CITY OF ALBUQUERQUE

RE: ABC Building Expansion Grading Plan Stamp Date: 10/19/18 Drainage Plan Stamp Date: 9/20/18 Hydrology File: H14D001B

RE: ABC Building Expansion Grading and Drainage Plan Engineer's Stamp Date: 9/20/18 Hydrology File: H14D001B

GRADING & DRAINAGE PLAN

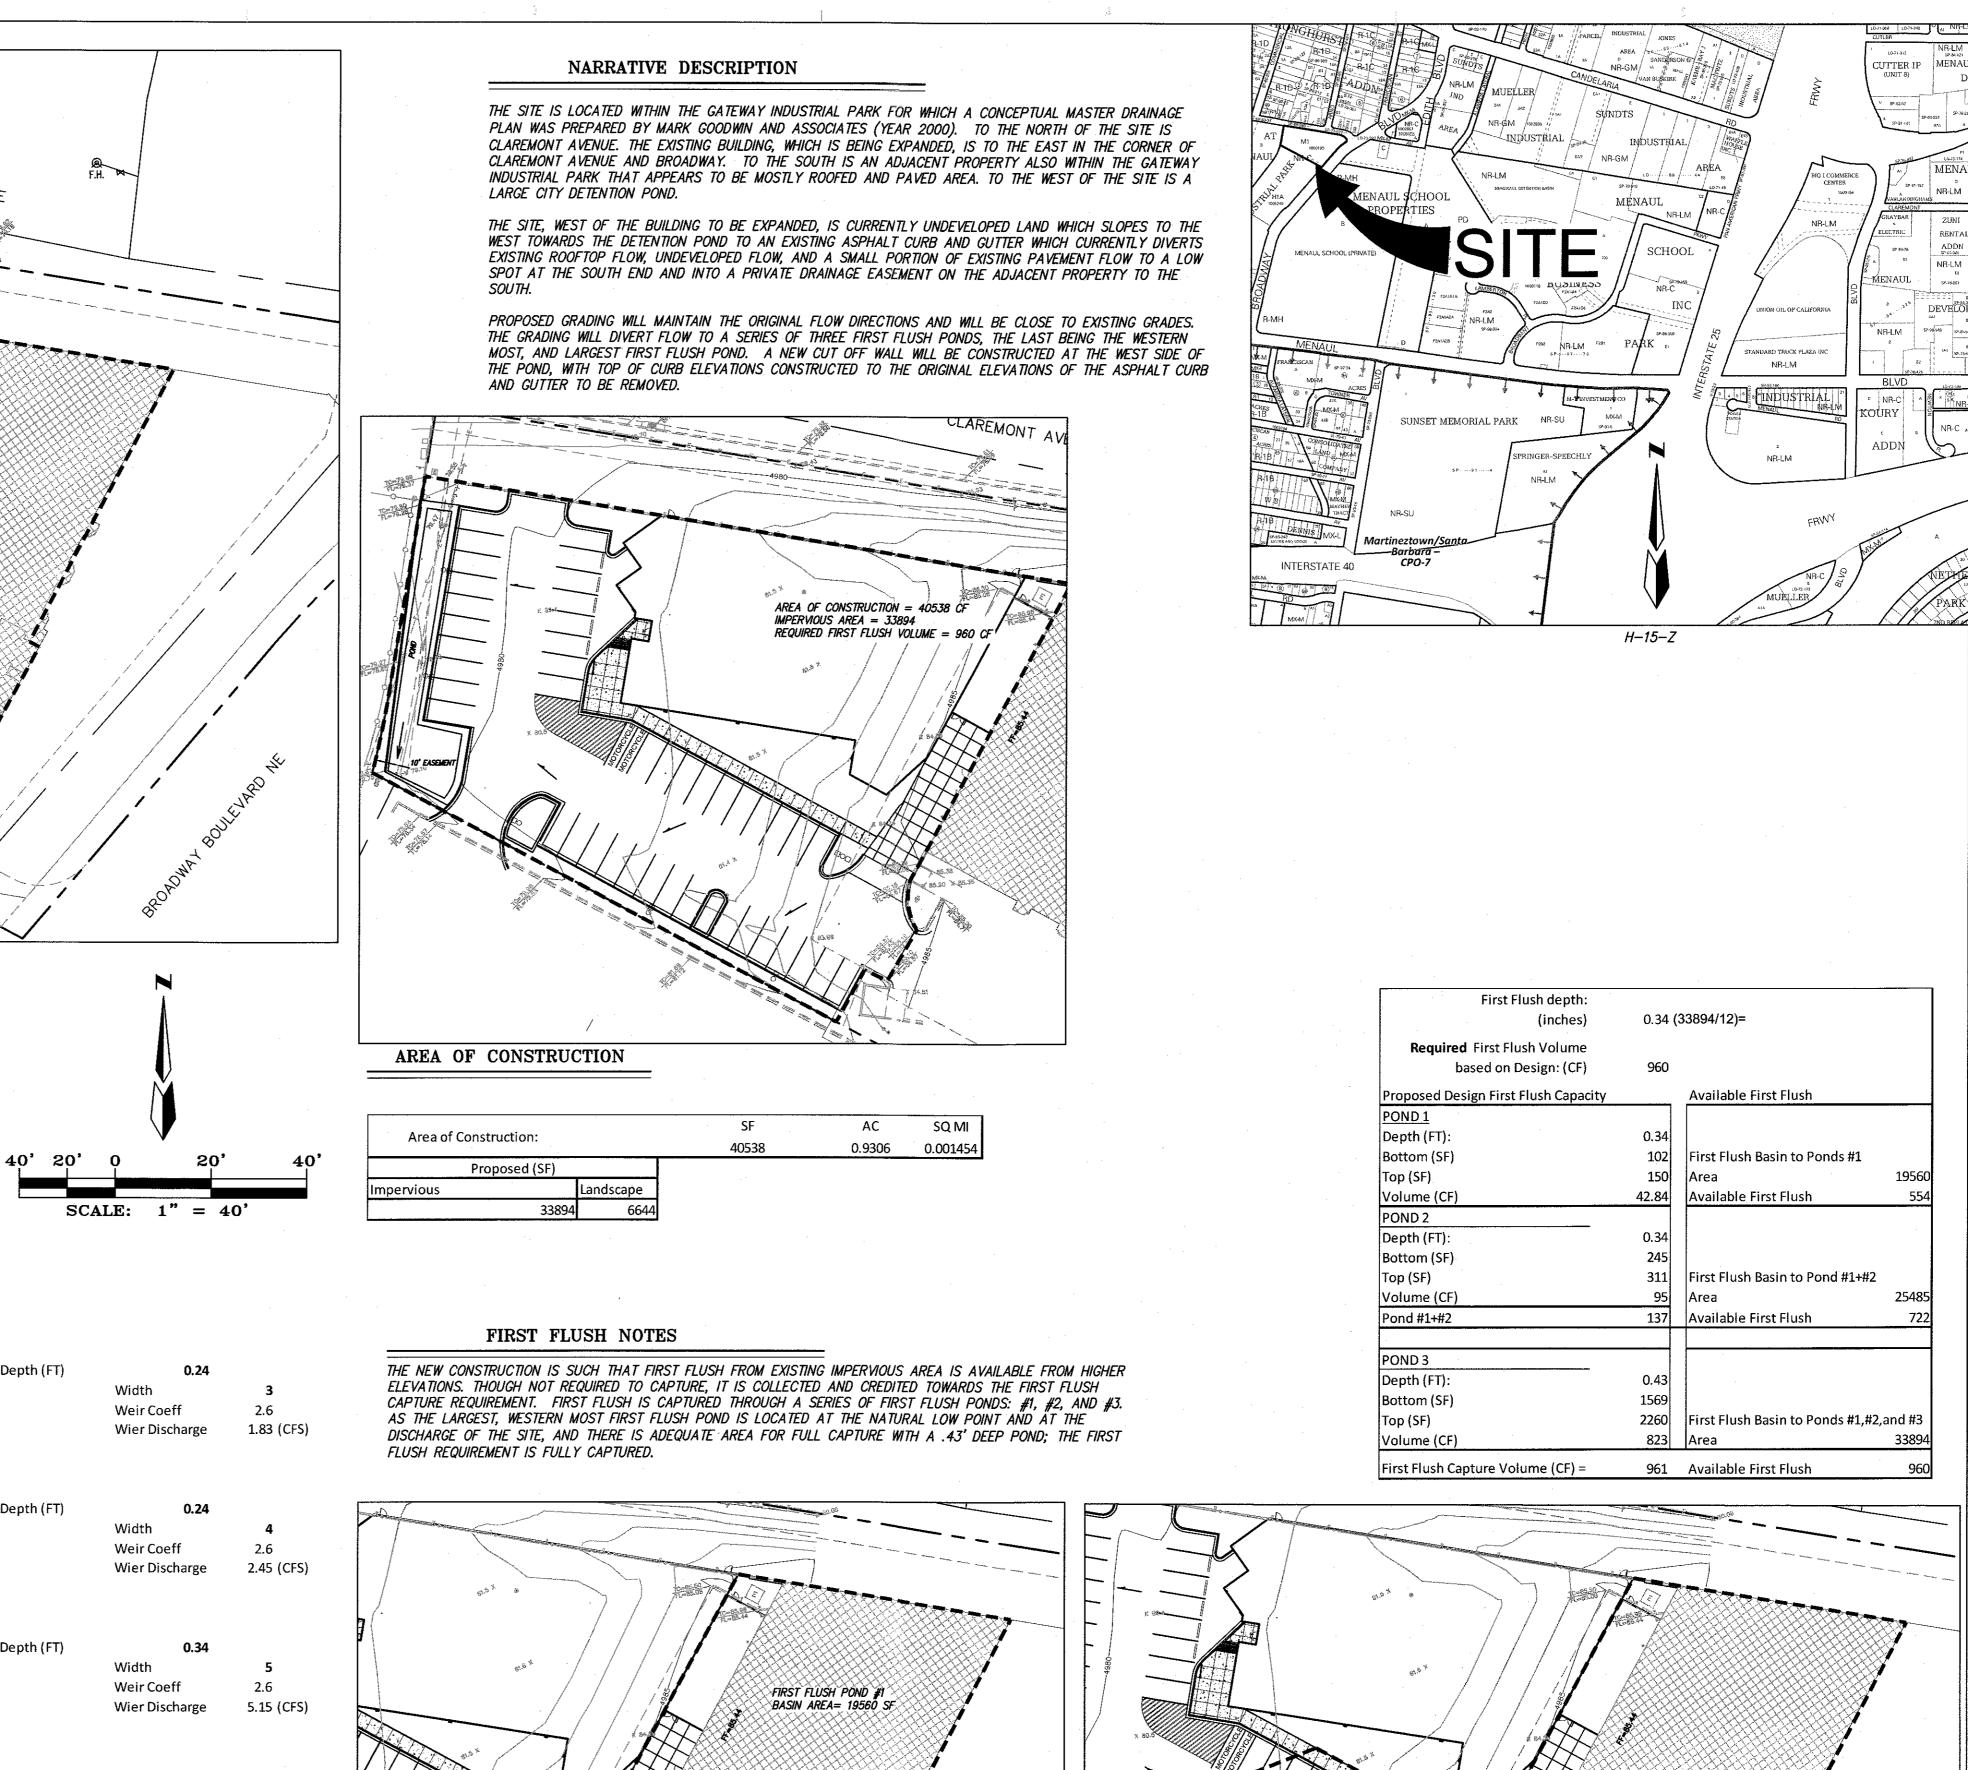
Based on the submittal received on 10/19/18, the grading and drainage plan is re-approved for Site Plan Building Permit, Grading Permit, and Building Permit.

Albuquerque 1. Engineer's Certification, per the DPM Chapter 22.7: *Engineer's Certification Checklist For Non-Subdivision* is required.
